NM1 - 53

**RE: Request for Additional Information – Permit Application Review for a Proposed Commercial Surface Waste Management Facility
Envirotech, Inc. – Landfarm #4
Facility Location: Sections 6, 7, and 8, Township 26 North, Range 10 West, NMPM
San Juan County, New Mexico**

Request for Additional Information
Envirotech, Inc. – Landfarm #4
Commercial Surface Waste Management Facility
March 24, 2011

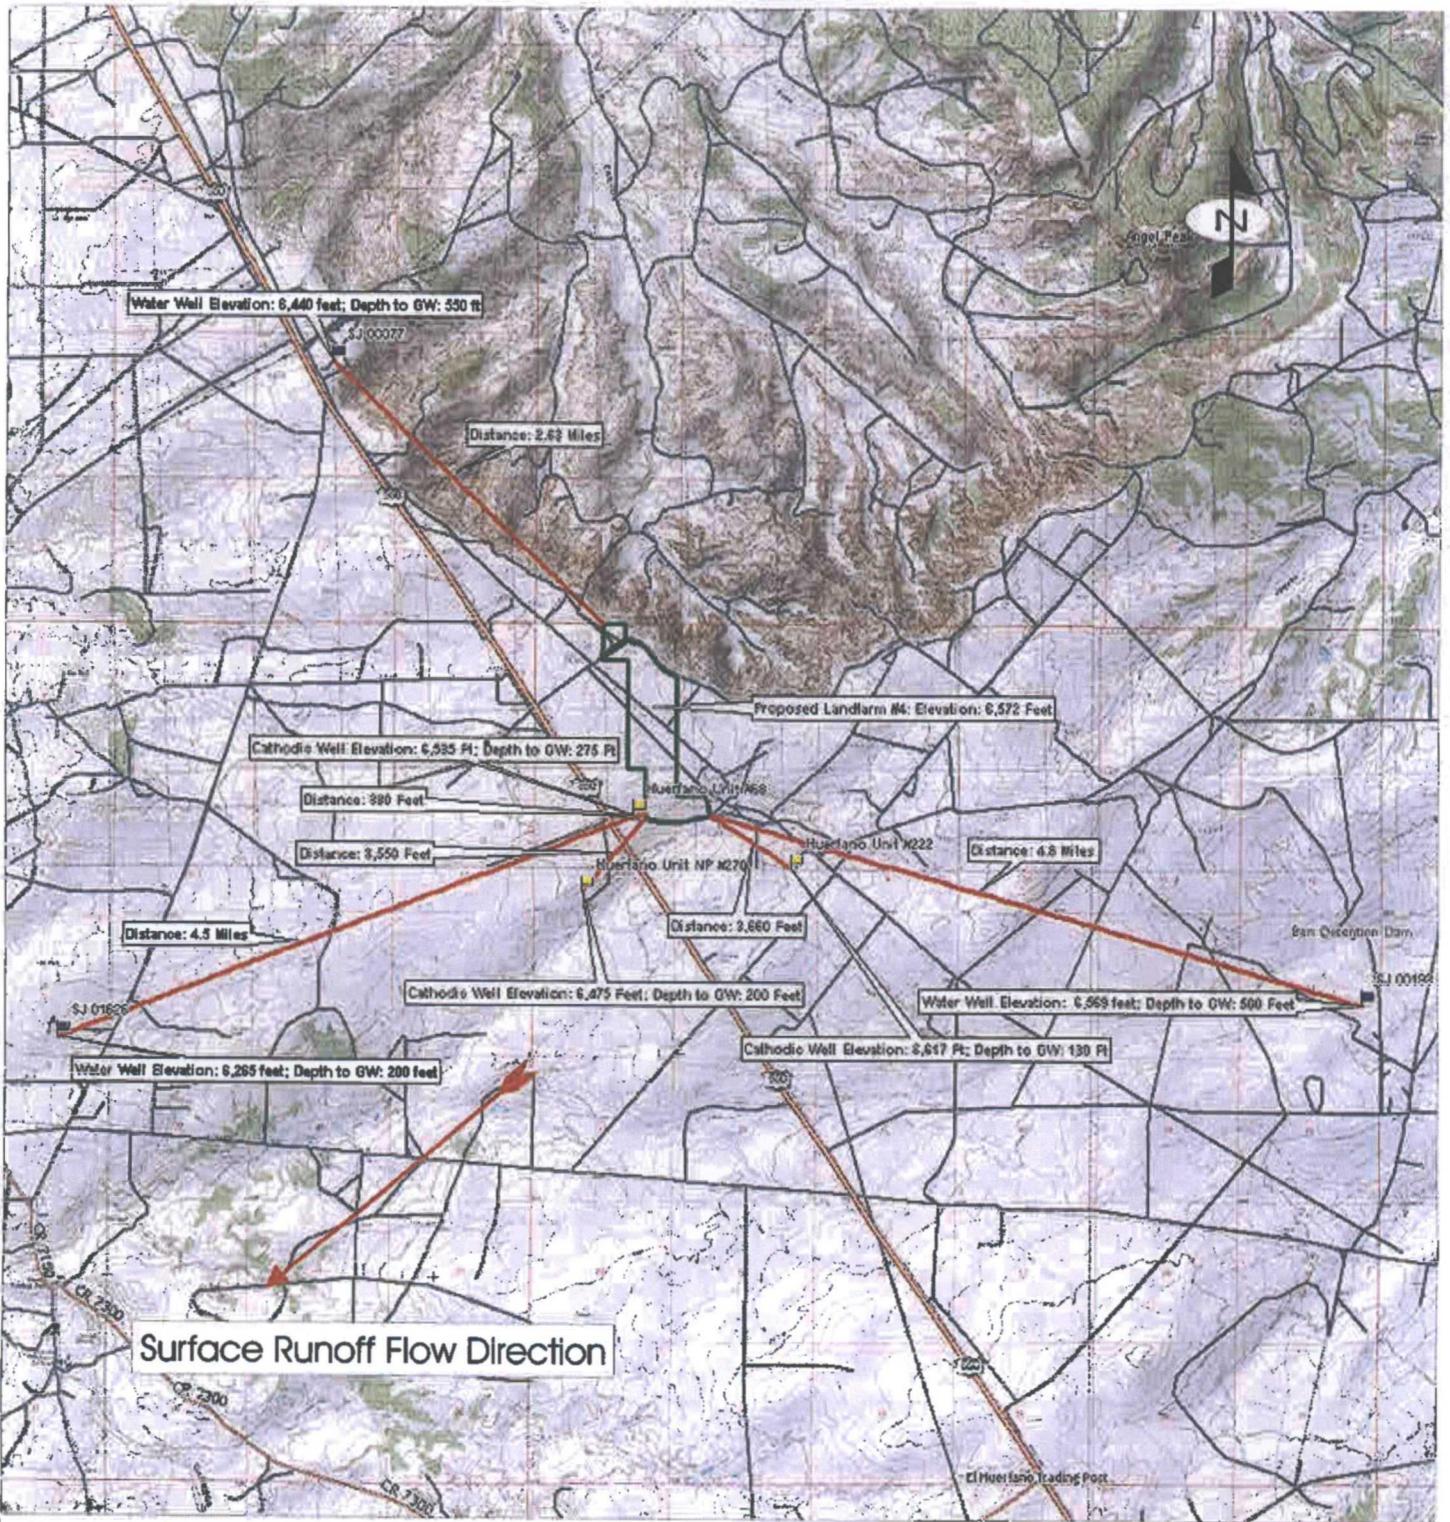
Figure 2, Hydro-geologic Map Water Wells: The text and information provided on this map is too small and is not legible. Also, the topographical features are not present on the map to support the “regional” surface run-off flow direction. The landfarm elevation presented on the map is inappropriate since is an “average elevation” and there are conflicts between the measured data on Figure 1 and the survey plat provided in Attachment 3. Please provide a legible map or maps that support the conclusions based on the map and illustrate the information provided on the current map.

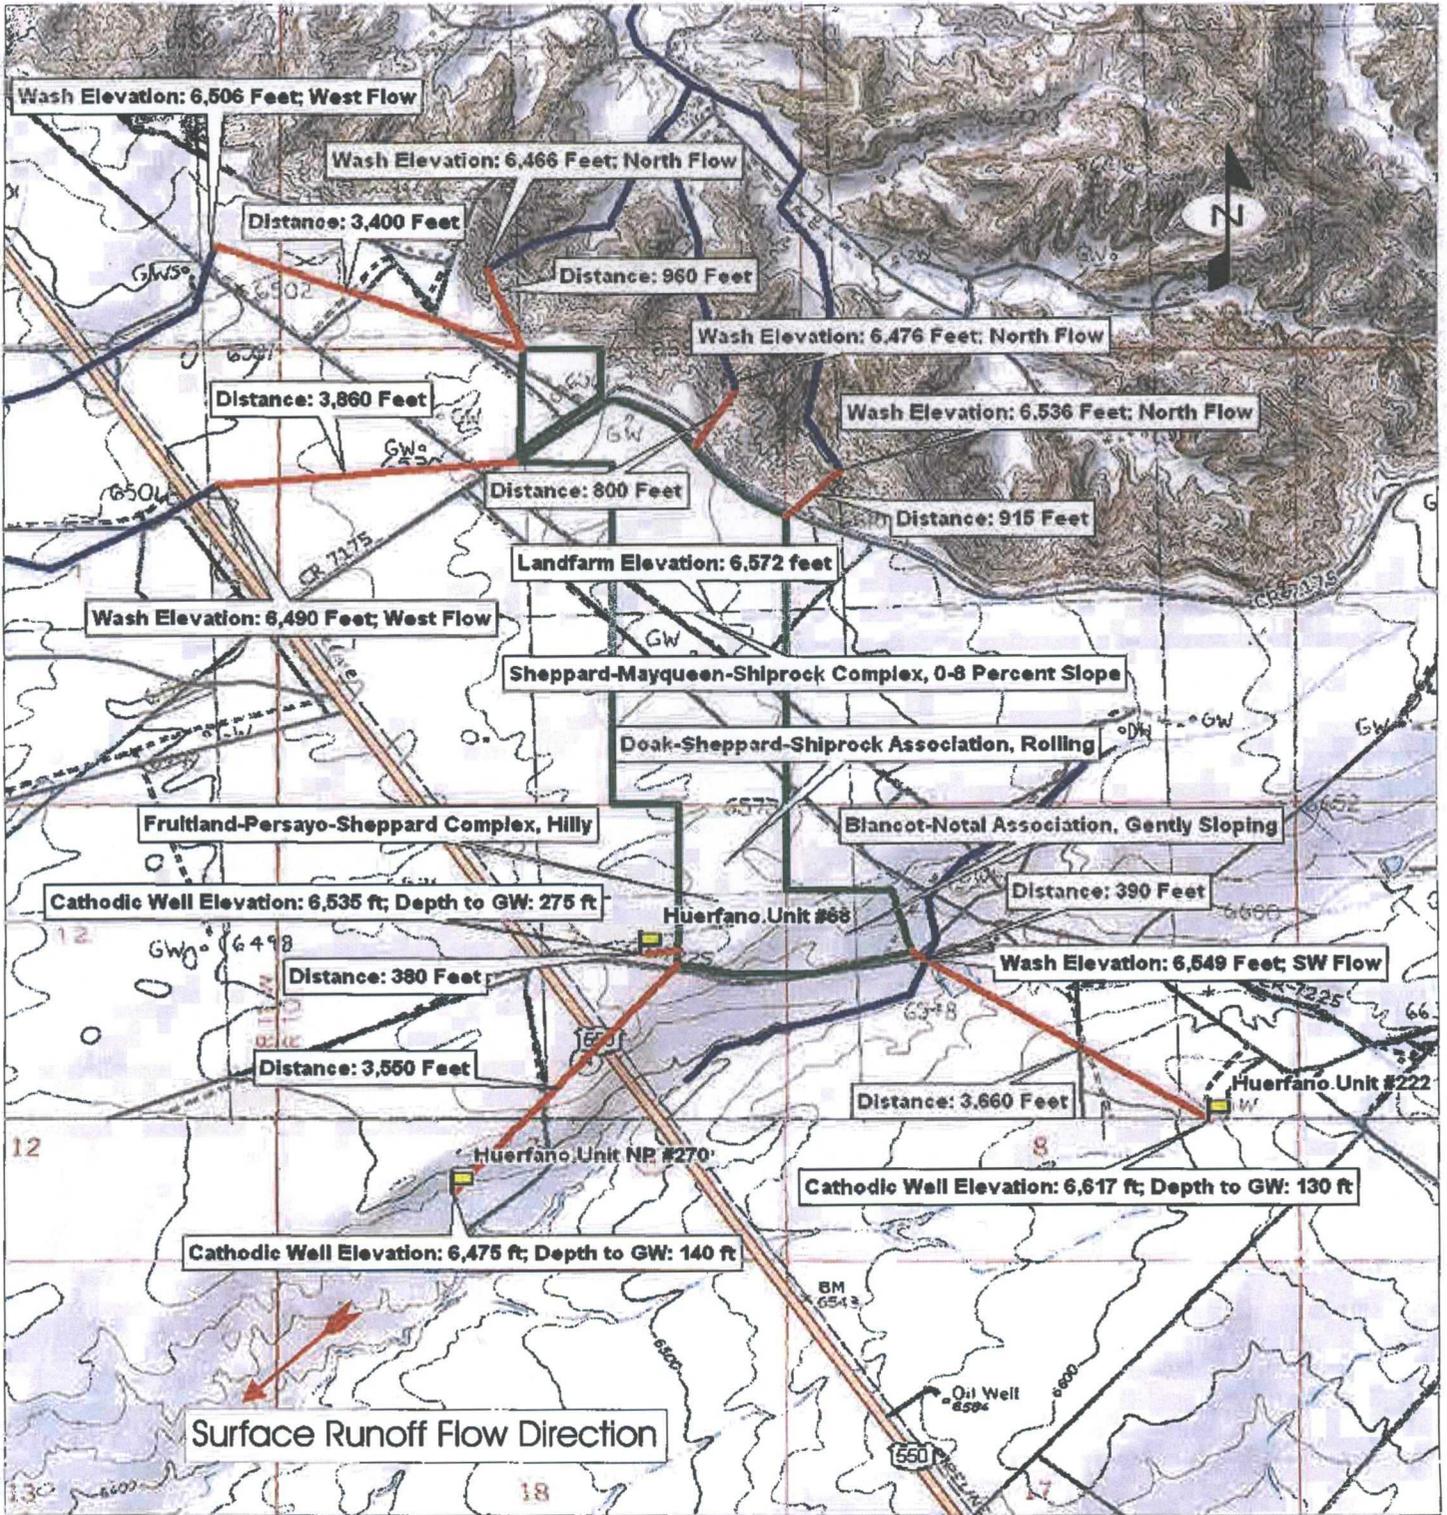
Figure 3, Hydro-geologic Map Cathodic Wells: This map tries to illustrate too much information and is inappropriate for the illustration of certain information. This map is not appropriate for the illustration of the soil description information, especially since the transitions between soil types and classifications cannot be properly identified. Also, the topographical features presented on the map to only support the “regional” surface run-off flow direction. An assessment of the site-specific surface water flow conditions has not been completed to determine appropriate locations for the construction and installation of run-off and run-on control features. The landfarm elevation presented on the map is inappropriate since is an “average elevation” and there are conflicts between the measured data on Figure 1 and the survey plat provided in Attachment 3. Also, as illustrated on Figure 3, the distance measured from the south-east corner of the proposed facility boundary to the illustrated wash is $1/16^{\text{th}}$ of an inch. Based upon the scale provided on Figure 3, one inch equals 2083.3 feet. Therefore, the measured $1/16^{\text{th}}$ of an inch equals 130.20 feet which is also the distance measured and documented on the August 21, 2009 Landfarm Facility Inspection Sheet provided in Attachment 13. Figure 3 currently states that this distance is 390 feet. Please clarify and provide an appropriate map or maps to properly illustrate the information.
